RE: Request for Additional Information
Wayland Town Office Discharge Site
Transmittal No. X250635

Tighe & Bond has prepared the following response to your letter dated June 15, 2012 which requested additional information regarding the proposed groundwater discharge at the Wayland Town Offices. The response that follows uses the same numbering system as the Department's letter (Attachment A) and a copy of that letter has been appended to this document for reference purposes.

RE: Request for Additional Information
BRP WP 83/Hydrogeologic Evaluation Report
Transmittal Number X250635

**Town Office
Building
Groundwater
Discharge**

FIGURE 4-3R

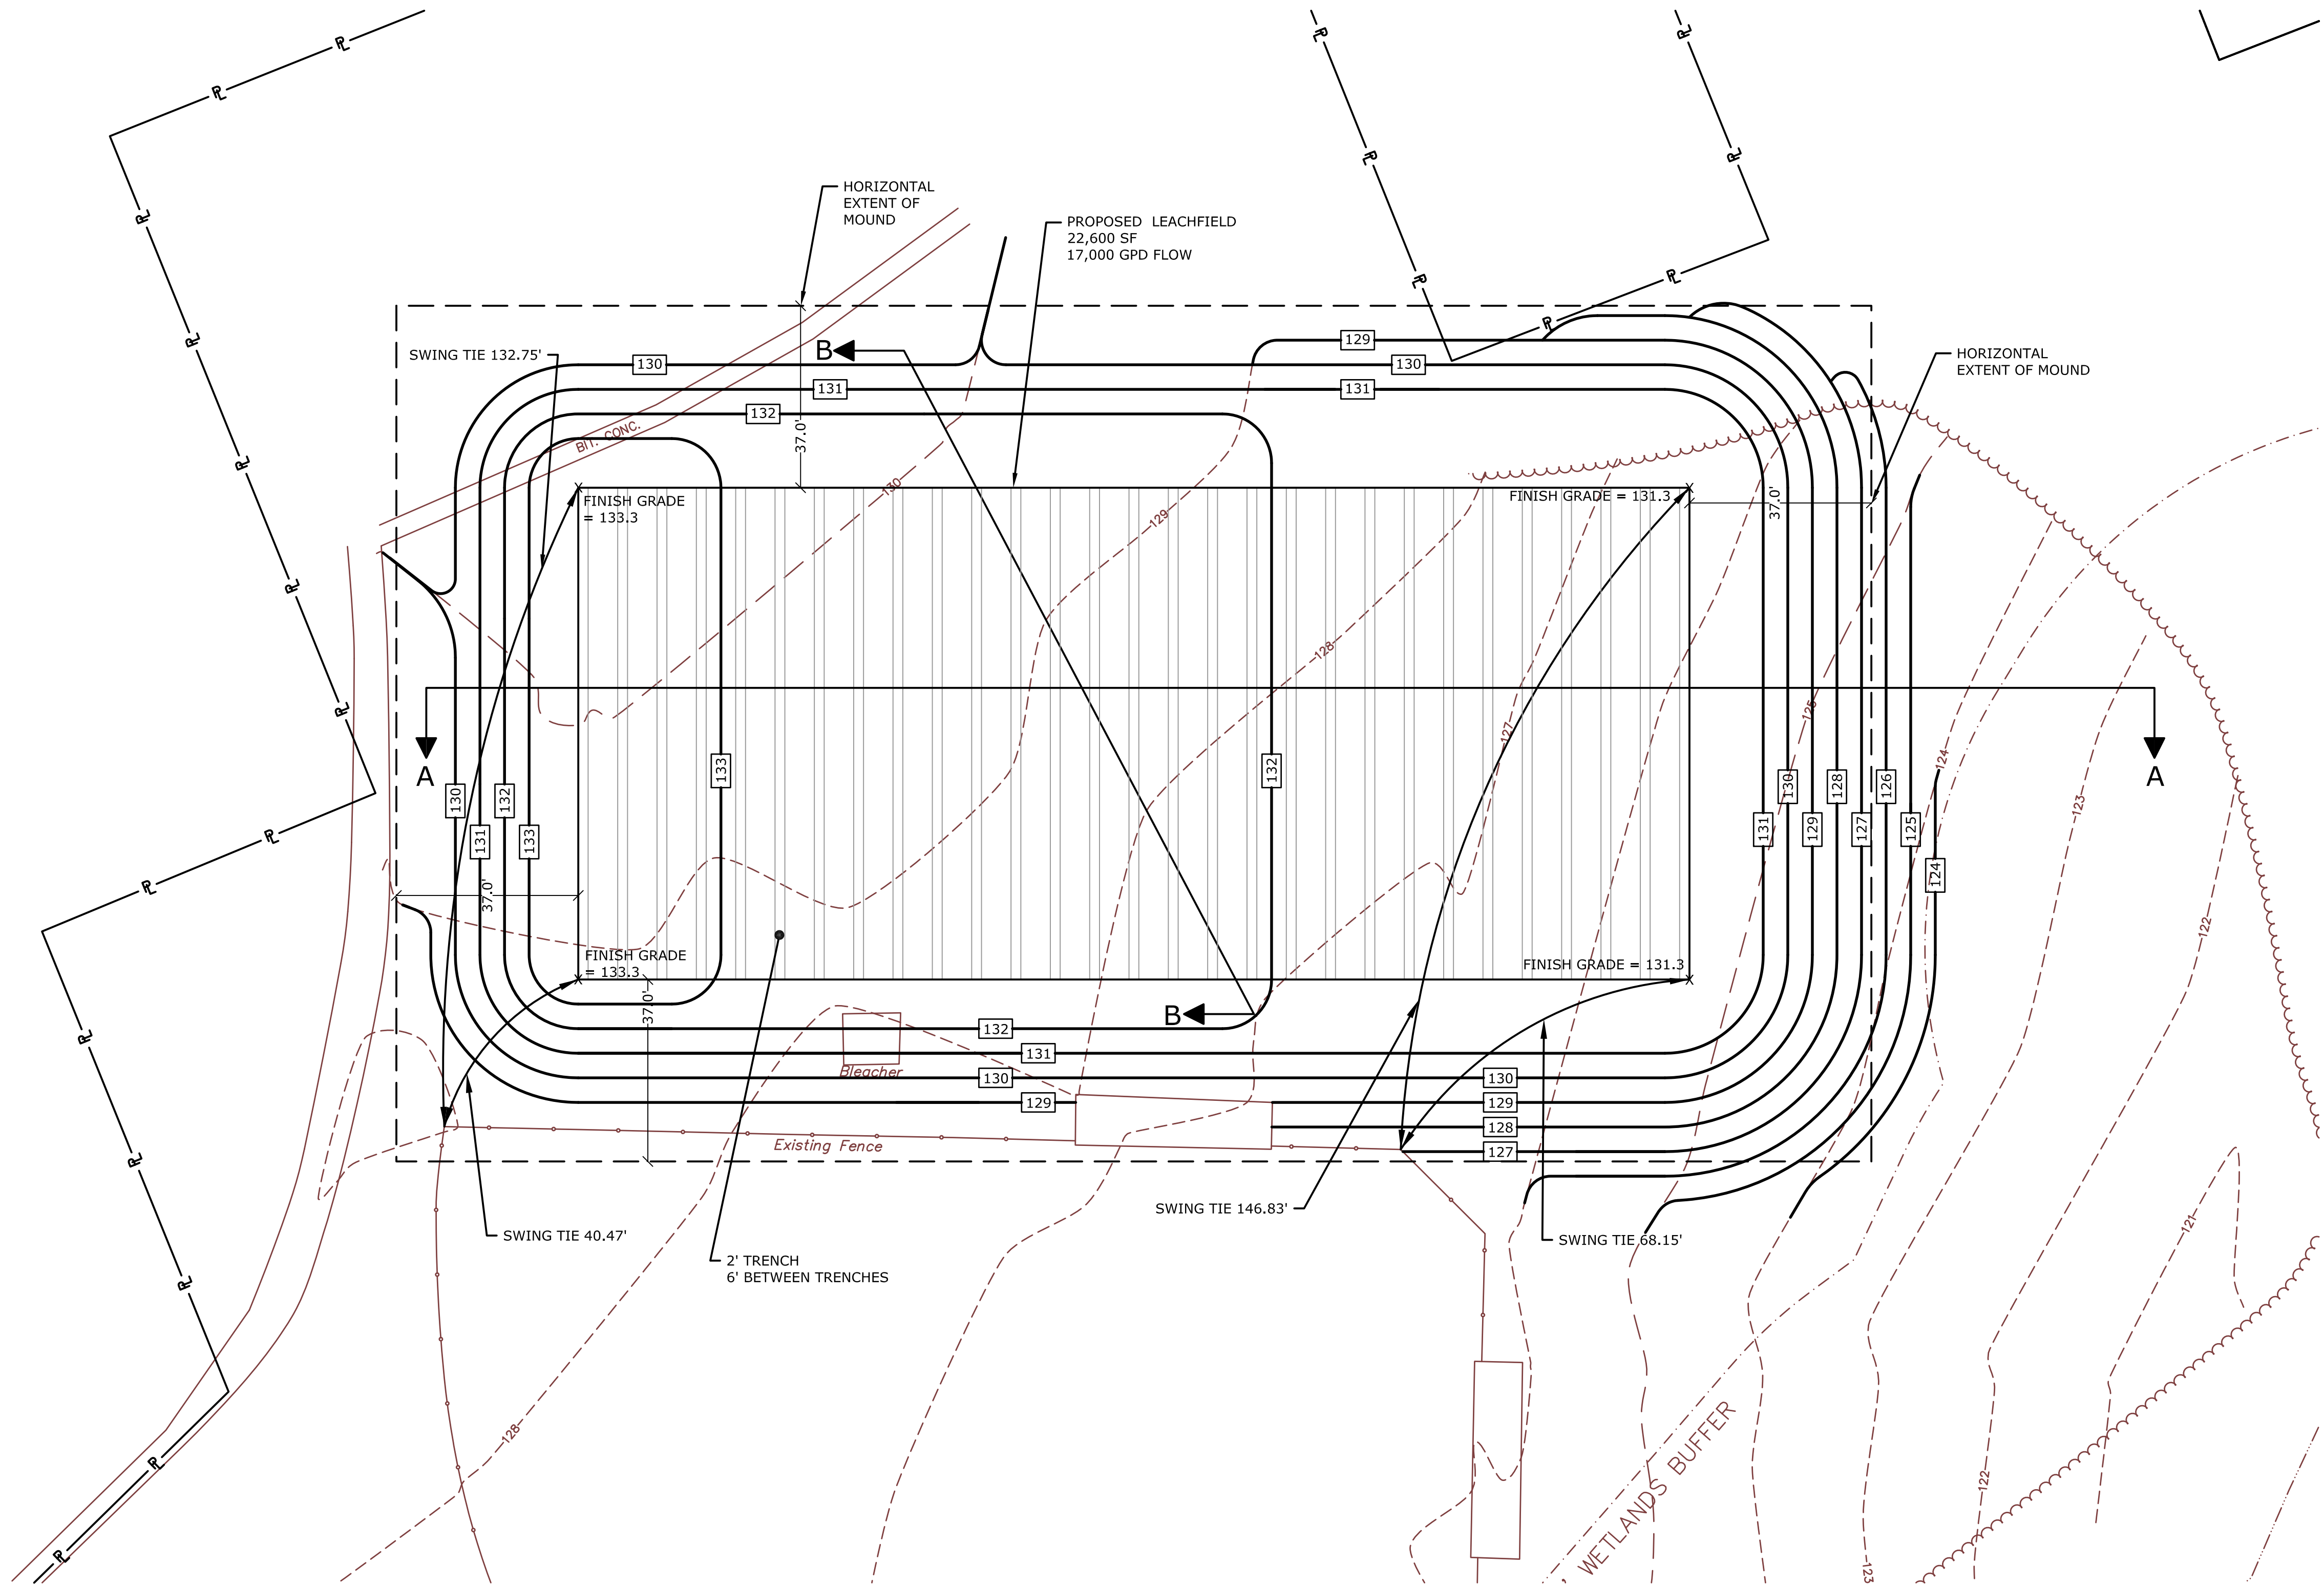
6. T&B shall construct a post-disposal groundwater contour plan showing the effects of groundwater mounding on estimated seasonal high groundwater and include it in the hydrogeologic report.

8. The submitted hydrogeologic report shall be expanded to include a groundwater monitoring plan capable of identifying and assessing any impacts to groundwater flow and quality resulting from a discharge of effluent at the proposed location. A minimum of three monitoring wells (one upgradient and two downgradient) are required. Monitoring wells installed as part of the site investigation may be utilized provided they are appropriately located and constructed in accordance with MassDEP's *Standard References for Monitoring Wells*. Additional well locations may be needed to monitor impacts to abutting properties and downgradient sensitive receptors.

Issue #6 – A post construction groundwater contour plan has been included as Figure 4-3R in Attachment D.

Issue #8 - One upgradient and two down gradient monitoring well locations have been identified on Figure 4-3R, provided in Attachment D. These locations were selected based on regional groundwater flow patterns and property ownership constraints. The latter constraint has produced an 'upgradient' well location that is probably better described as cross-gradient. In spite of this issue, we believe that the well indicated as UG-1 will still accurately capture ambient groundwater conditions and meet the intent of the Department's requirement. If the discharge area is ever constructed the proposed wells will be installed in accordance with the prevailing Department guidelines on well construction at that time.

FIGURE 5-2R

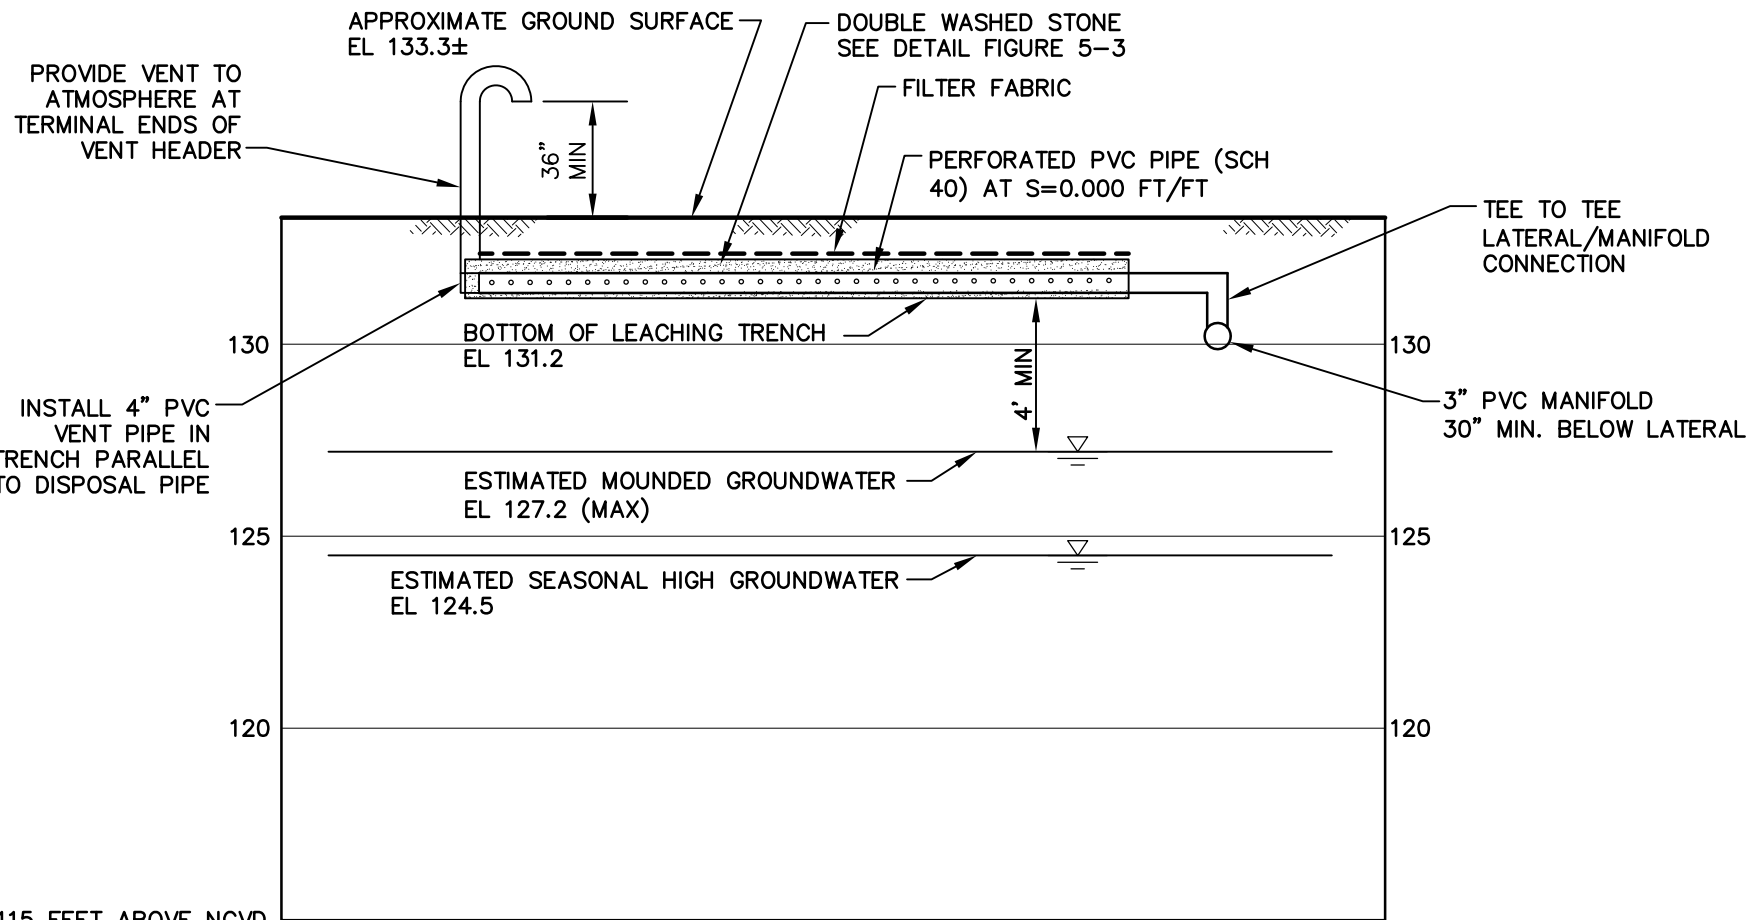
3. The SAS proposed by T&B consists of a 200' by 100' drip dispersal field. The field was sized using a loading rate of 0.85 gpd/ft². The maximum loading rate permitted by MassDEP for drip dispersal is 0.74 gpd/ft². T&B shall revise its report to reflect the use of the correct drip dispersal loading rate, or propose the use of a different infiltration technology and support the final loading rate used to size the SAS.

Issue #3 – Tighe & Bond's previous design was based on loading rate guidance from the drip disposal system manufacturer (Oakson, inc.) and a review of loading rates utilized at other similar projects. This design approach was used because; a) the Department has no published guidelines under the Groundwater Discharge program "Guidelines"¹ indicating specific loading rates for drip dispersal, and b) drip dispersal systems are essentially functionally identical to pressurized PVC pipe and trench dispersal systems which the Department does address in the "Guidelines". Based on the similarity to PVC pipe systems, we believe that drip systems could be safely implemented at loading rates similar to those approved for PVC pipe systems, which in this case would be a loading rate of 2.5 gpd/sf. Our prior design utilized a loading rate of 0.85 gpd/sf to minimize mounding on the site and did not approach the loading rate described above. In citing the 0.74 gpd/sf loading rate developed for drip dispersal systems under the Title 5 I/A program, we believe that the Department is taking an overly conservative approach on the design recharge rate. Designs regulated by the I/A program rely on some level of treatment in the SAS and do not receive the same highly treated effluent that will be produced by this project. Given that this system will receive highly treated effluent from a membrane bioreactor (MBR) WWTF, there is little risk of solids fouling of the system and there is no need for vadose zone treatment of effluent. Both Tighe & Bond and Oakson have discussed these and other related issues with senior Department staff over the last six weeks, however we have not received definitive guidance on the matter. Given the time constraints imposed on this project due to pending litigation, we have revised our design to utilize a more traditional trench discharge system. This system has been laid out using 1 ft (D) by 2 ft (W) trenches and a loading rate of 1.47

gpd/sf. Revised mounding calculation for this system have been included in Attachment C and updated plan and profile views of the system are included in Attachment D.
